COMMISSION ACTION FORM

SUBJECT: REVISED MAJOR SITE DEVELOPMENT PLAN FOR OLD ORCHARD
MANUFACTURED HOME PARK TO ADD A MAINTENANCE BUILDING

ATTACHMENT B: MAJOR SITE DEVELOPMENT PLAN-1

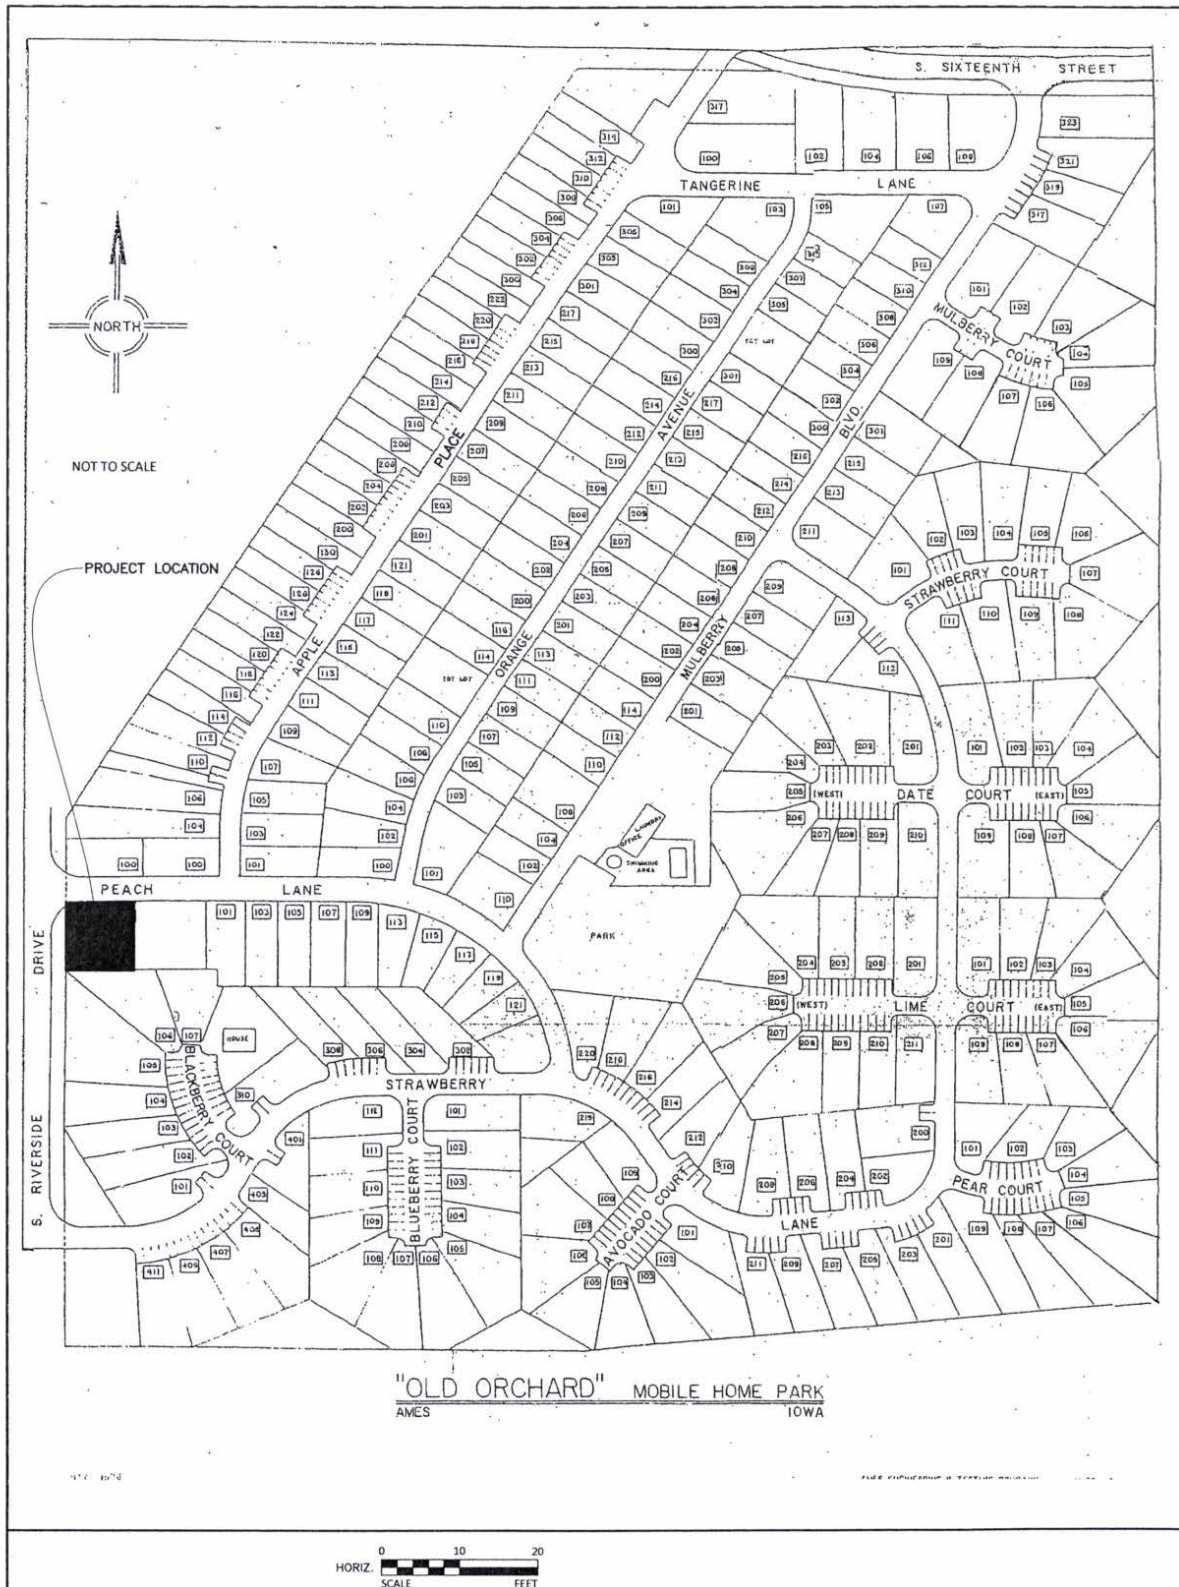
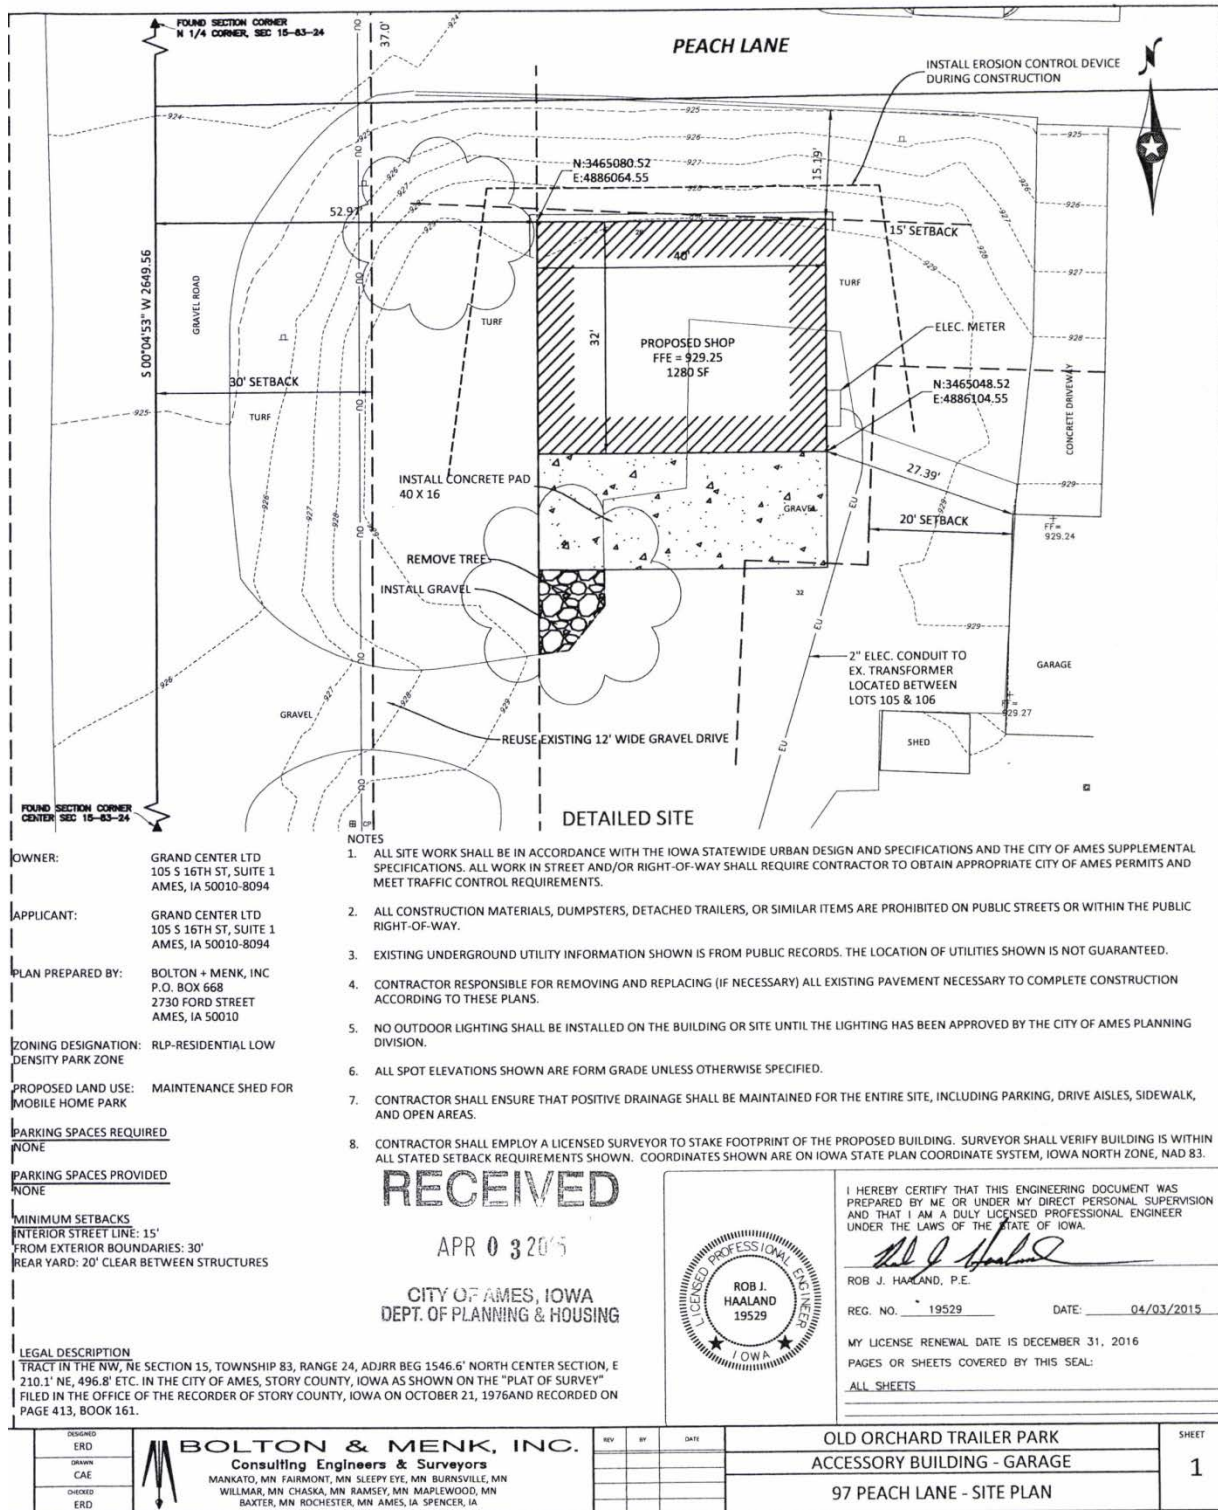
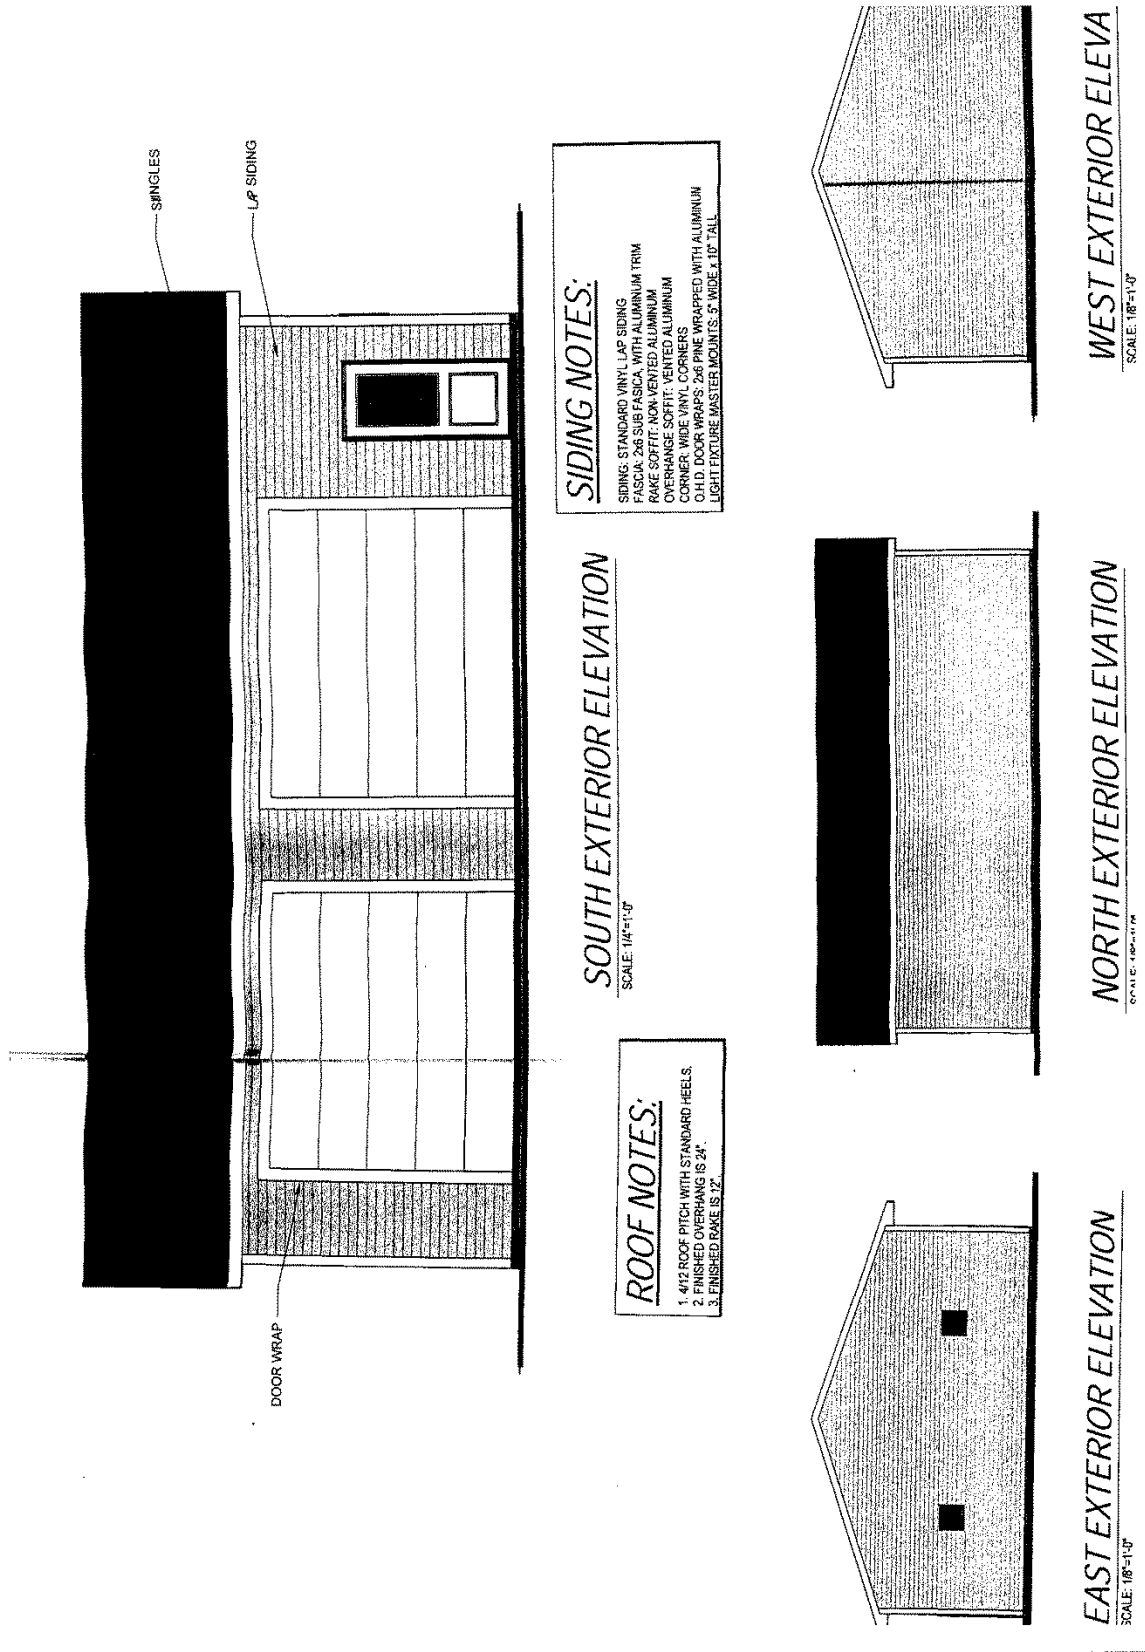
The proposed plan includes the one-story 1280 square-foot maintenance building located in conformance with the setback requirements. The building will have two garage doors on the south. It will be accessed with a gravel driveway from an existing gravel road to the west. Staff finds that the proposal fully conforms to all of the RLP Zone. (See Attachment B Major Site Development Plan)

In accordance with Section 29.1502(4)(d) of the *Municipal Code*, when making a recommendation upon an application for a RLP Major Site Development Plan approval or amendment, the Planning and Zoning Commission shall rely generally upon accepted site planning criteria and design standards. (See Attachment C) Staff has reviewed these criteria and standards and finds the proposal does not change the compliance of the Old Orchard Major Site Development Plan, with the exception of the proposed use of the current gravel driveway paving.

Zoning Ordinance Section 29.406 (11) requires that all vehicle areas be hard surfaced. The applicant has provided photographs documenting that the existing drive served a house that was on that site before this standard was enacted. Therefore, staff concurs that the driveway is legally non-conforming. However, Zoning Ordinance Section 29.307 (5) on this type of nonconformities states this policy:

Conclusions. Staff has analyzed the applicant's request, reviewed the supporting material, and conducted an on-site inspection. Based upon the above facts and analysis, staff concludes that the proposed maintenance building conforms to relevant and applicable RLP zone standards, as well as applicable site design standards for Major Site Development Plans, with the condition that the driveway be hard surfaced.

It is the recommendation of the Department of Planning and Housing that the Planning and Zoning Commission adopt Alternative #1 to recommend that the City Council approve the proposed revision to the Major Site Development Plan for Old Orchard Manufactured Home Park to add a maintenance building with the condition that the driveway be paved in conformance with Ames *Municipal Code* Section 29.406 (11).

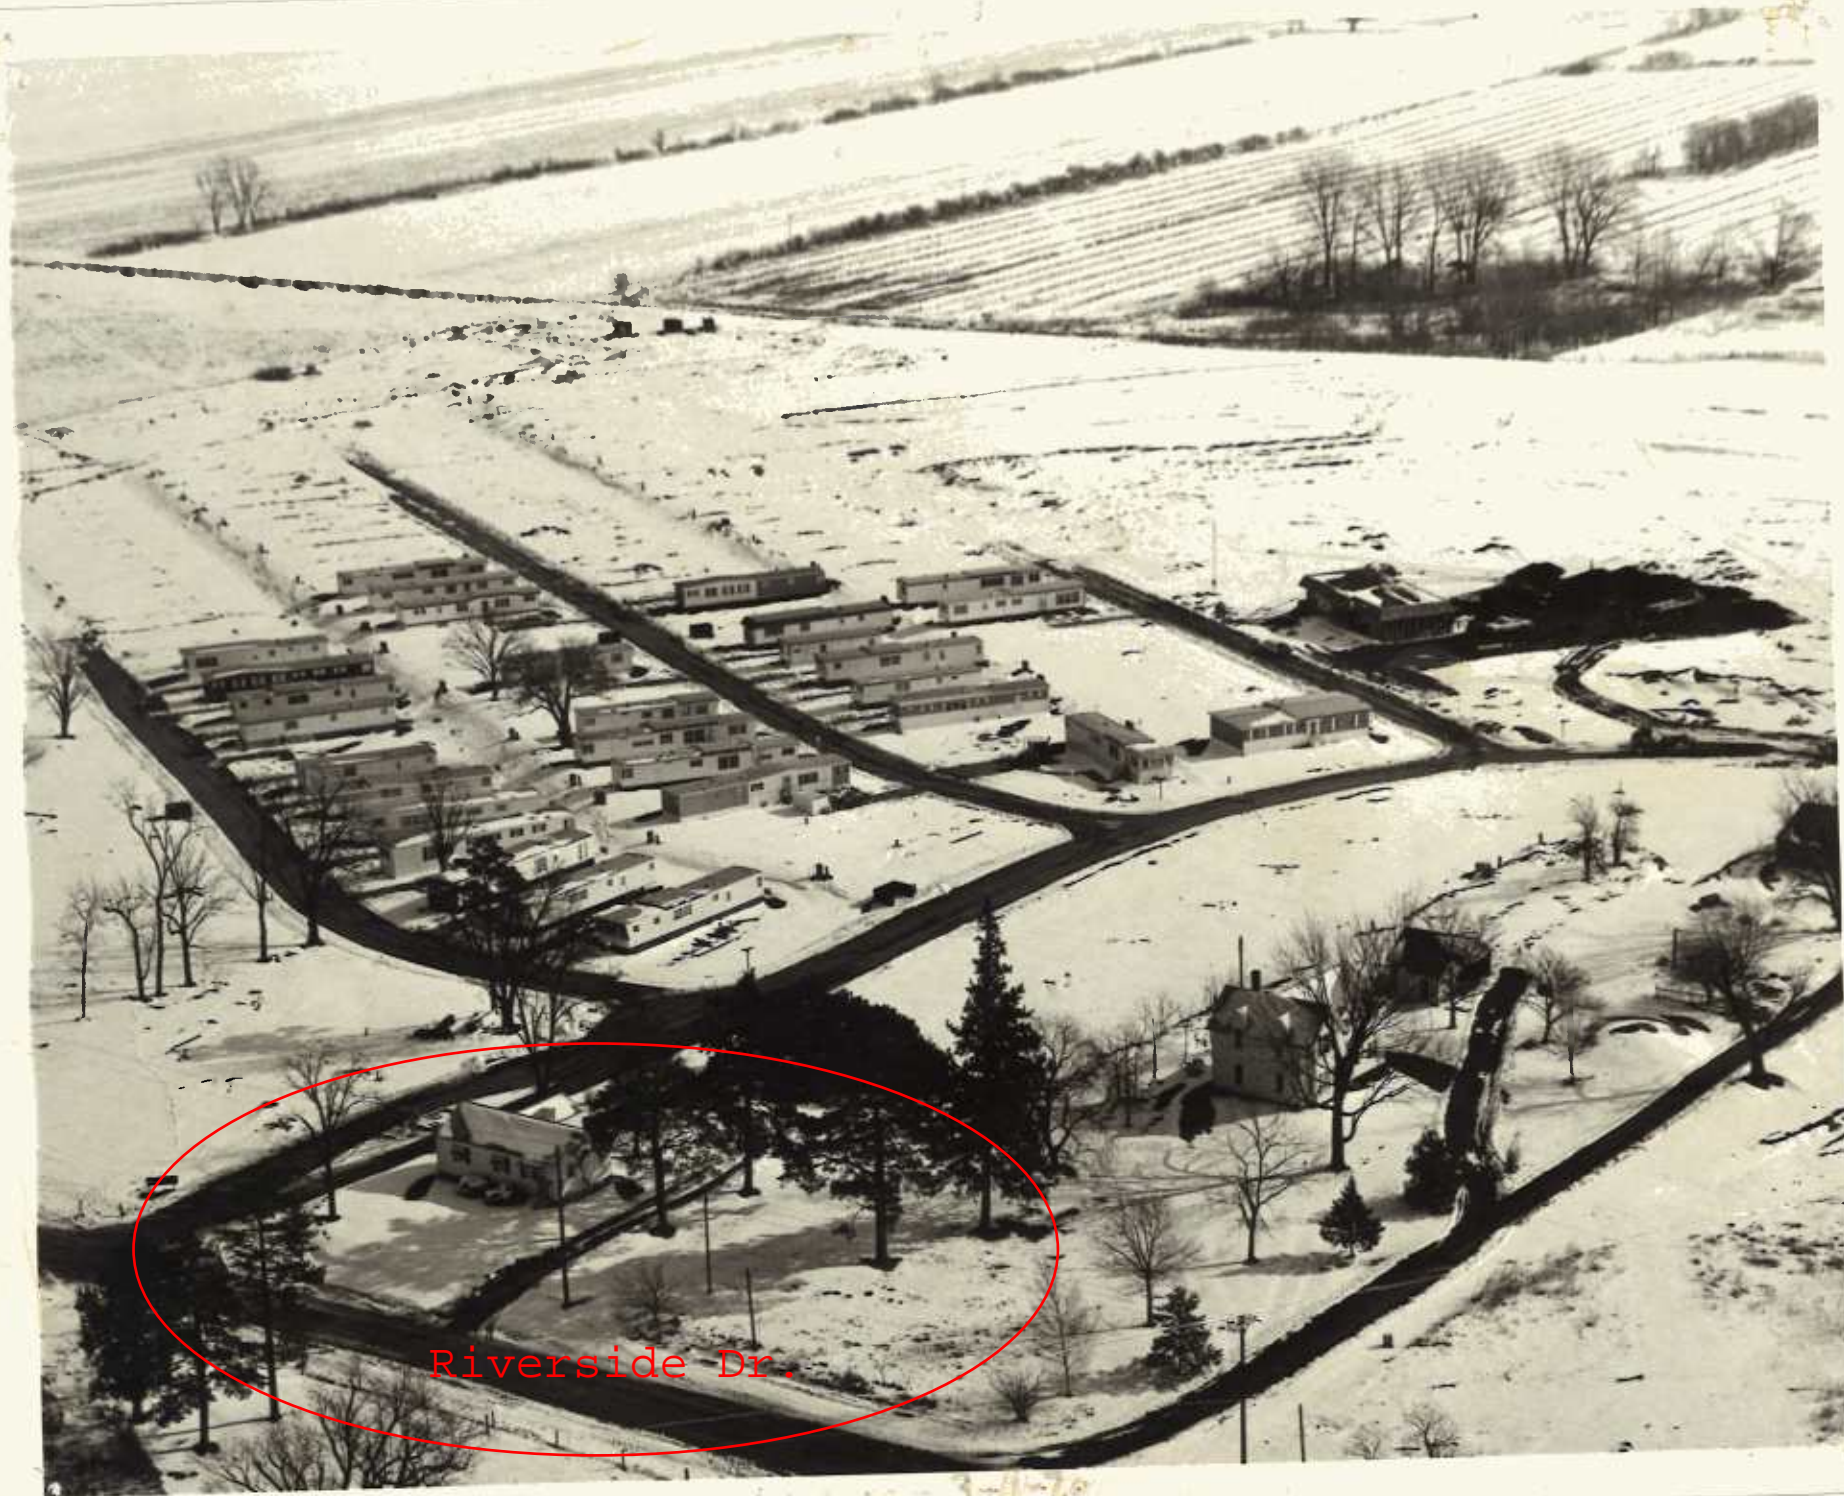
The driveway in question is an existing unpaved driveway that served the house originally located on the site. The house has since been demolished, but the gravel drive remains. The proposed maintenance shop will be located in the same vicinity as the original house. Attached you will find three aerial photographs taken on March 30, 1970, May 2, 1970 and circa 1981, respectively. All three show the original house and the unpaved driveway that connects to Riverside Drive.

We request that the City will consider this evidence and find that the driveway was in place prior to adoption of the Municipal Zoning Code and be allowed to remain unpaved in accordance with Section 29.307 of the Code. We hope that City staff will agree that it would be impractical to pave the driveway that abuts an unpaved street. Doing so would increase initial construction costs, and does not eliminate the need to drive on an unpaved street to access the site.
